FACPAC Contract Change Order Supplemental Information Form (Ref# 64866)

Tier 1 Project: CHHS Phase 2

Contract: SLA Enterprise, LLC, 0004, Structural Steel

ASI NO: Phase 2, 002

DESCRIPTION:

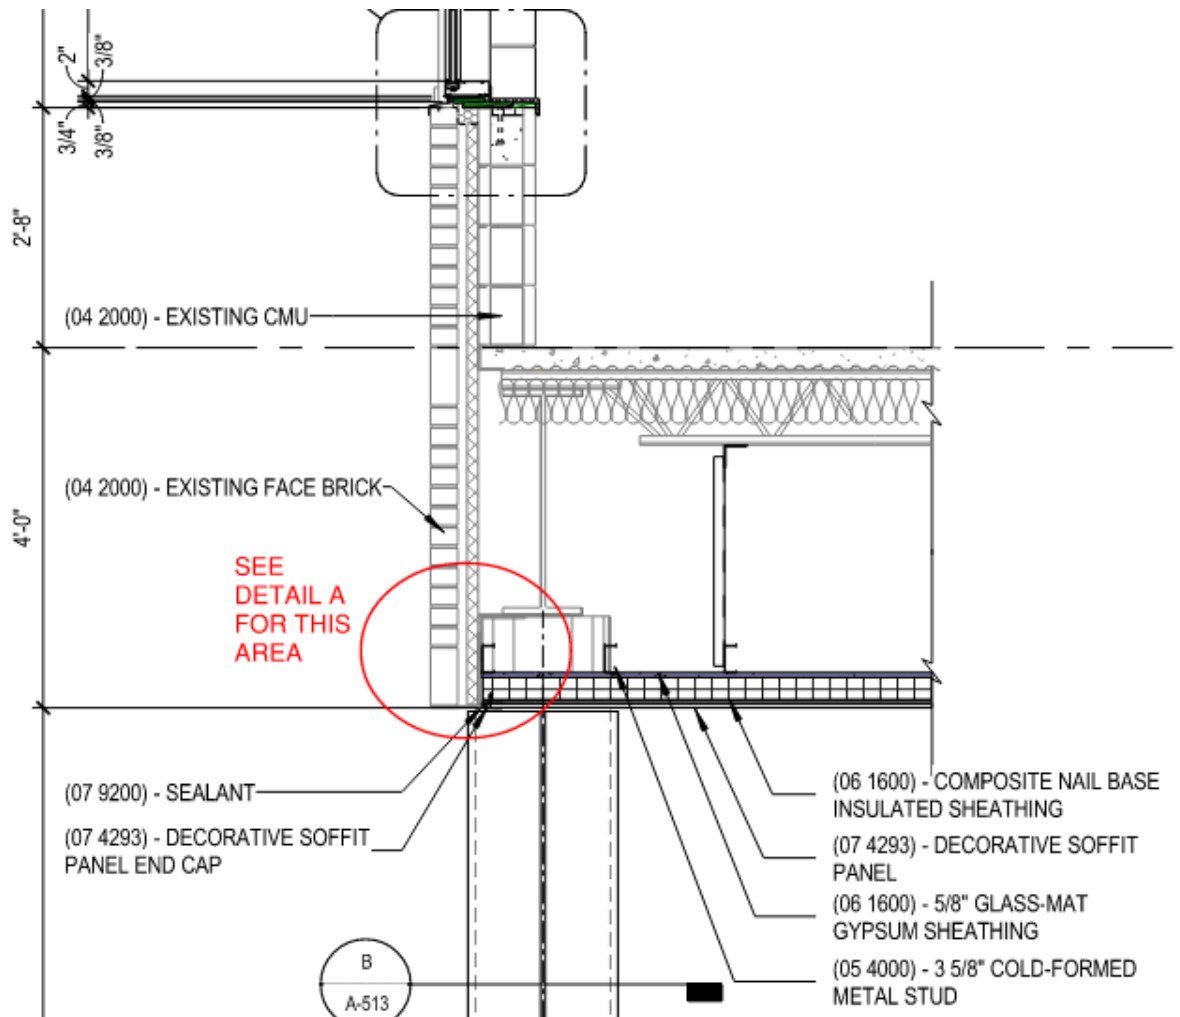
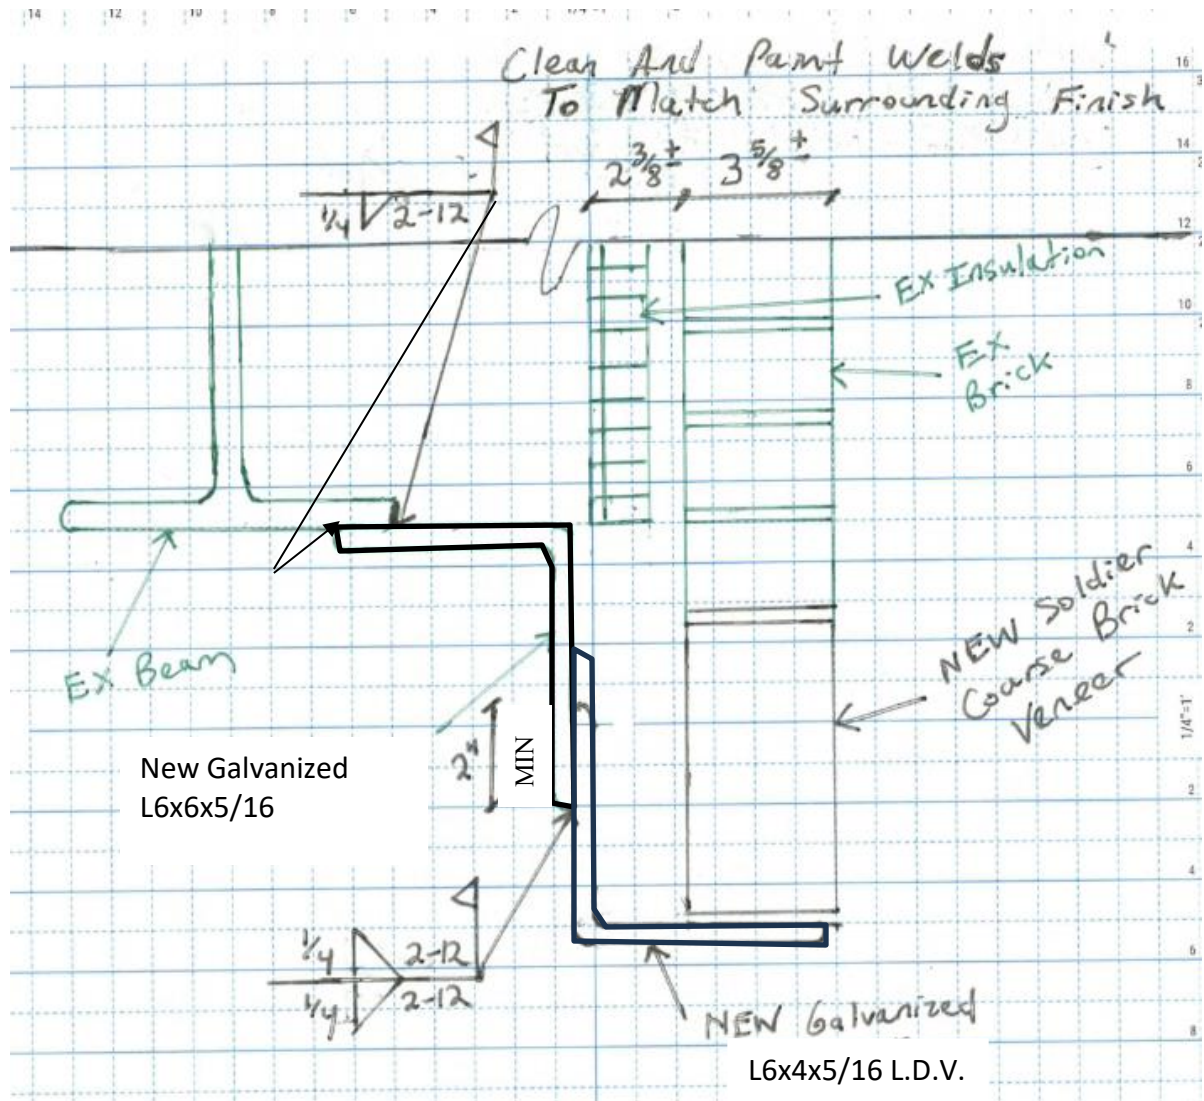
Field investigation and review of attached photos indicate that the existing edge angle supporting the brick veneer is in unsatisfactory condition due to water infiltration within the cavity. Water accumulation has led to significant corrosion of the edge angle, along with the failure of the top weld connecting this angle to an upper supporting angle that is welded to the existing structural beam. These welds are crucial for ensuring proper load transfer of the brick veneer into the structural beam and pose a threat to public safety in their current condition.

Contractor shall carefully remove and replace the existing soldier course of brick veneer and support angle system in four-foot segments, utilizing adequate shoring below the relief angle on each side of the cut-out sections to provide support to the brick veneer (and prevent overloading of the brick ties due to gravity selfweight). Remove brick soldier course and relief angle only over the width of the segment to allow the veneer above to arch between the shoring. Work may be simultaneously performed in a skip pattern of alternating 4 foot sequences; do not demolish adjoining sequence until new mortar is cured. New angles shall be galvanized, L6x4x5/16 (bottom) + L6x6x5/16 (top) and welded to the existing and to the existing steel beam with fillet welds. New flashing with a drip edge, weeps, and ties shall be installed. See **Detail A** for a detailed sketch of the proposed work. See **Appendix A** for elevation views of repair locations (to be three sides of terrace at Area J).

NOTE: NEW SOLDIER COURSE BRICK VENEER AND ANGLES MUST BE REPLACED IN 4 FOOT SECTIONS. WORK MAY BE SIMULTANEOUSLY PERFORMED IN A SKIP PATTERN OF ALTERNATING 4 FEET SEQUENCES; DO NOT DEMOLISH ADJOINING SEQUENCE UNTIL NEW MORTAR IS CURED. CONTRACTOR IS TO ENSURE ADEQUATE SHORING IS IN PLACE TO PREVENT THE TRANSFER OF ADDITIONAL LOAD INTO THE EXISTING BRICK TIES.

REFER TO WALL SECTION A/A-361

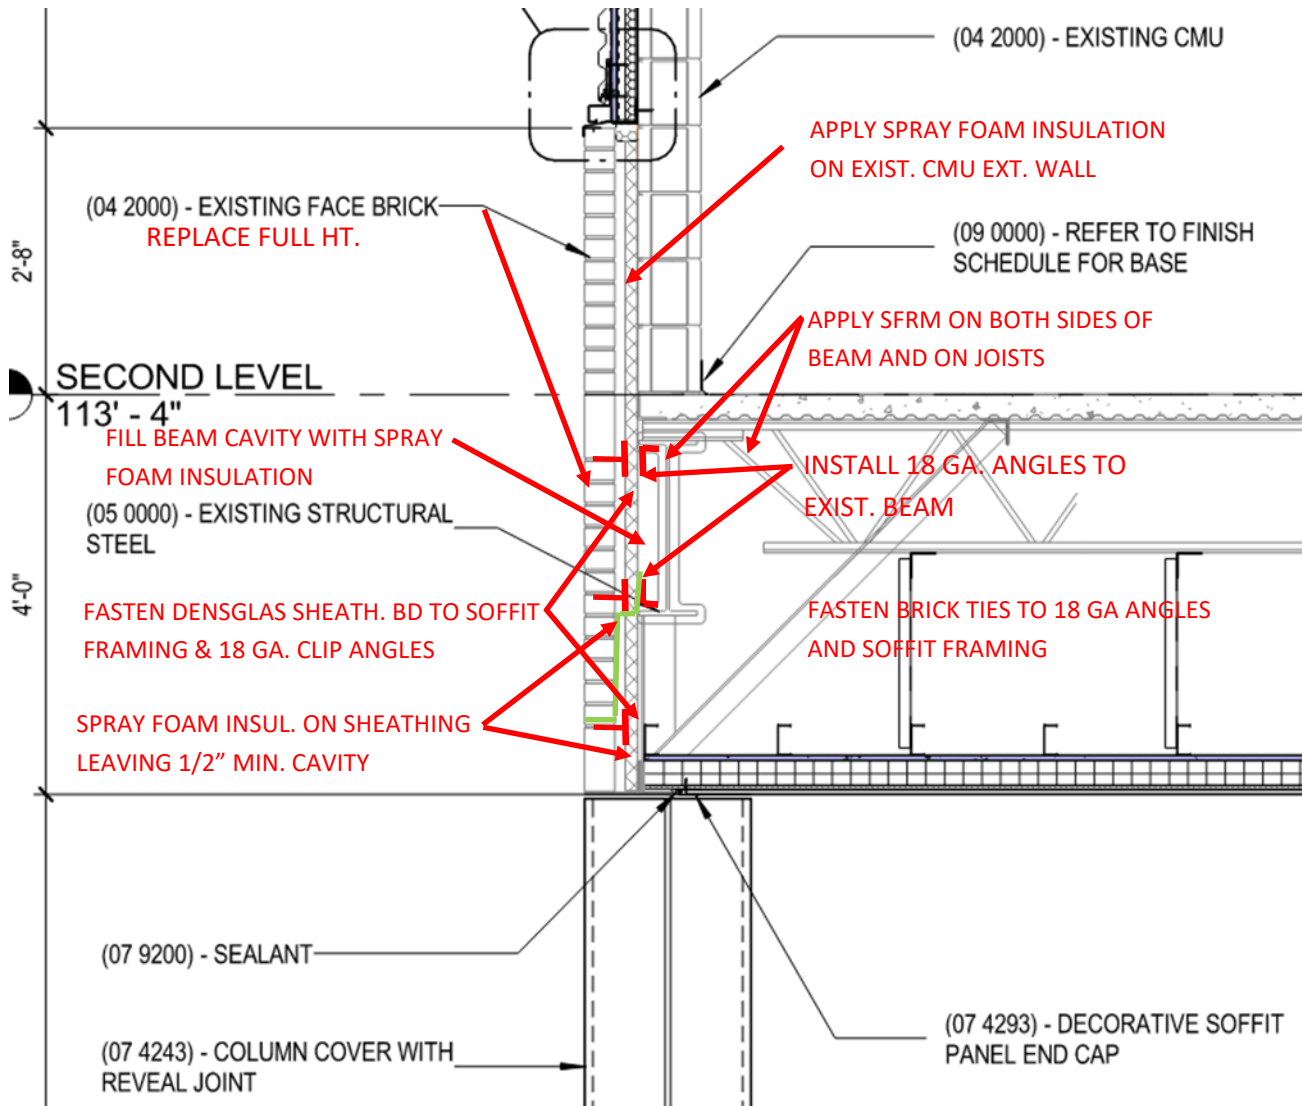
Provide pricing as noted in attached detail for brick and support angle at overhang in Area J.

REVISED 2-25-2026
